Heritage Minerals Inc.'s (HMI's) Plan for the Decommissioning and Decontamination (D&D) of the Site Subject to NRC License #SMB-1541

Re: Heritage Minerals, Inc. (HMI) Final Status Survey Plan

Enclosed are Heritage Minerals Incorporated's (HMI's) responses to The Nuclear Regulation Commission's (NRC's) and New Jersey Department of Environmental Quality (NJDEQ's) comments on HMI's proposed final status survey plan (FSSP) for license termination. We hope HMI's responses adequately address to the comments on the FSSP. Please do not hesitate to call if you have any further questions.

RESPONSE TO NRC'S AND NJDEP'S COMMENTS ON HMI'S FSPP

FIGURE 2

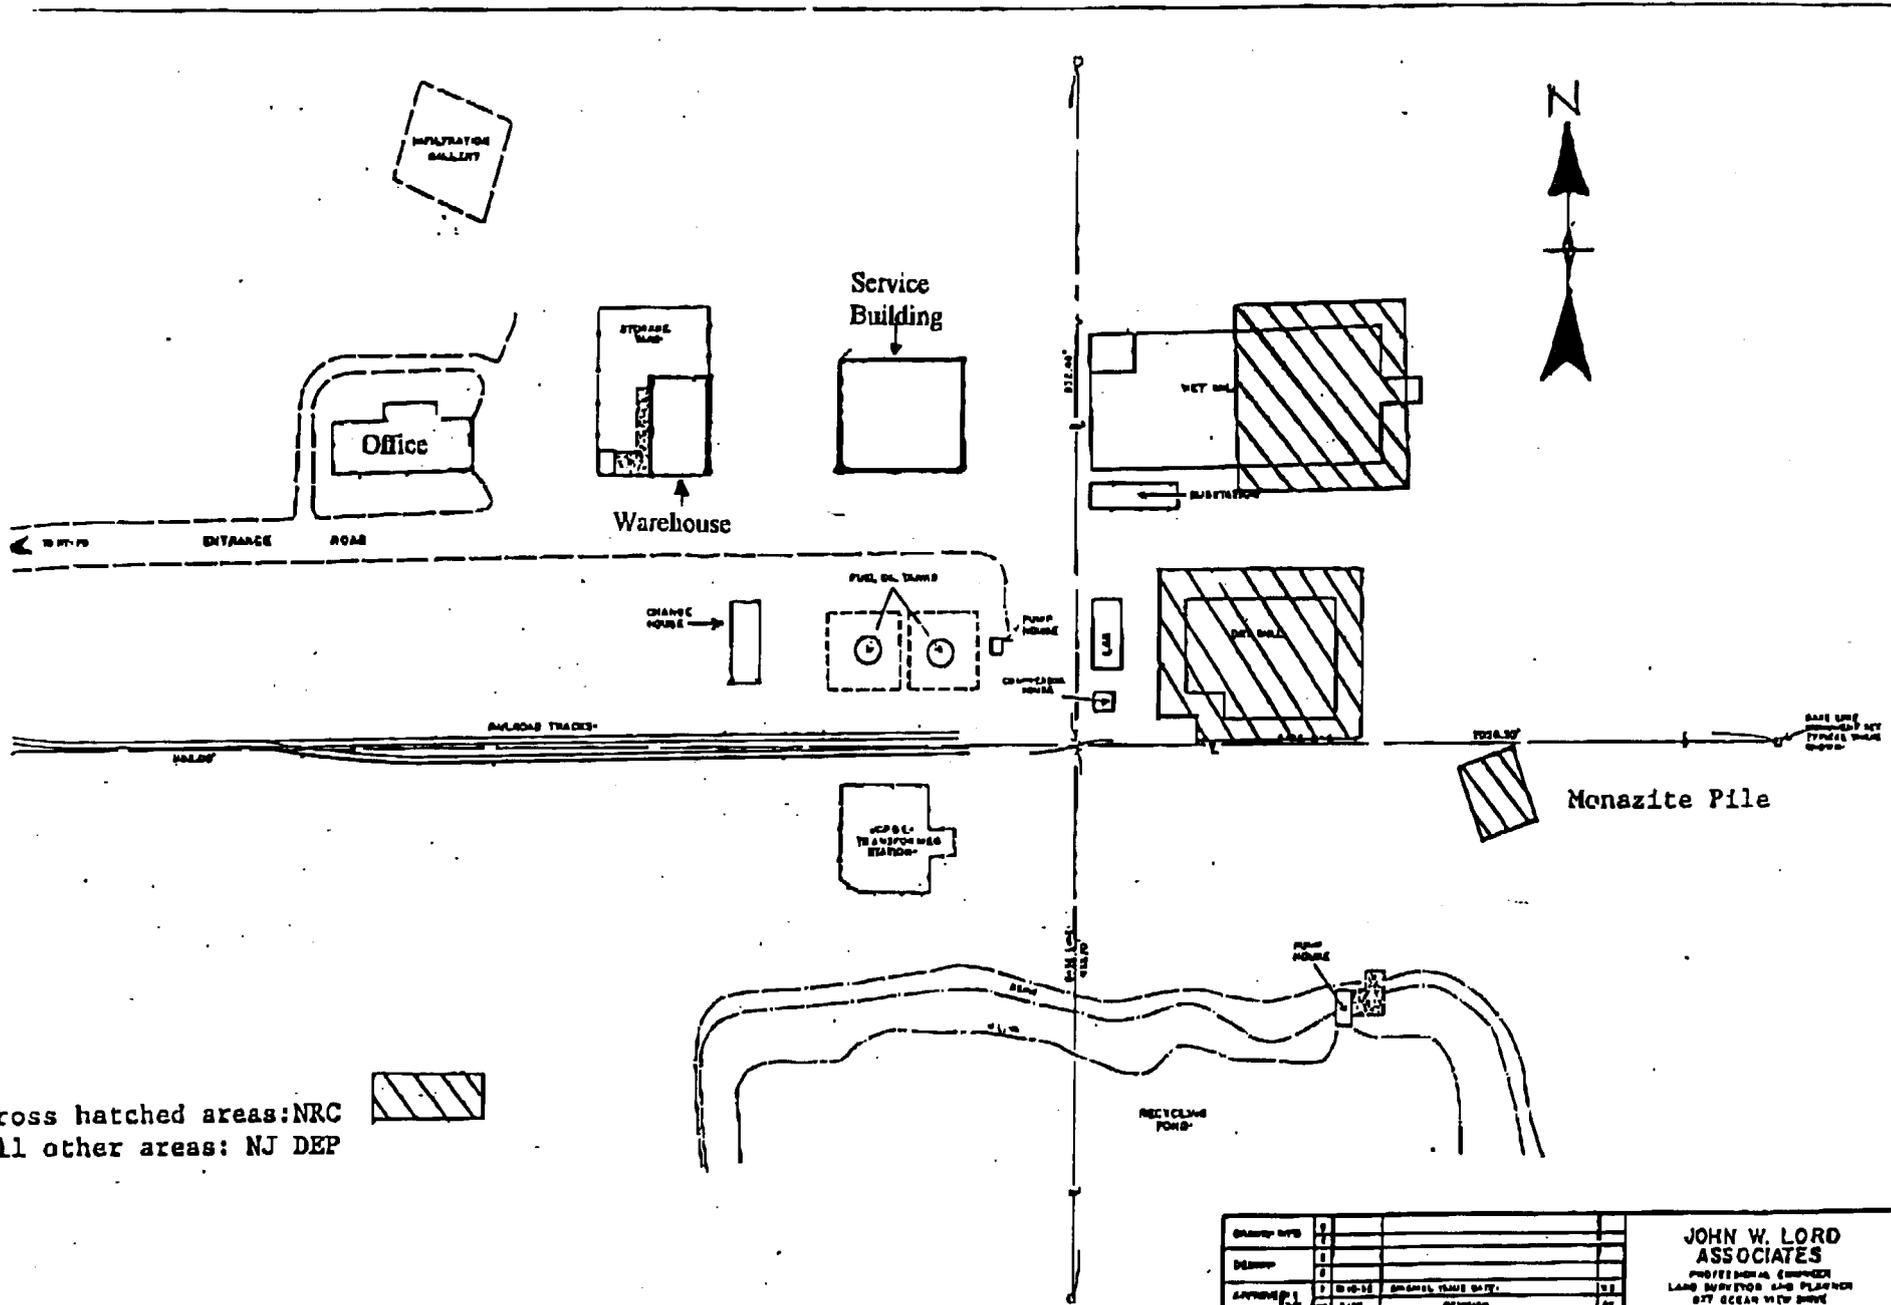
4. **Comment:** Figure 2 has no indication of north.

Response: A copy of a revised Figure 2 from the RSI FSSP showing an N arrow is attached. Also, please note that the hatching indicating the extent of the NRC areas of interest has been removed from the service building, warehouse, change house and office. The legend "*all other areas NJDEP*" was not clearly defined and the scale being incorrect were removed.
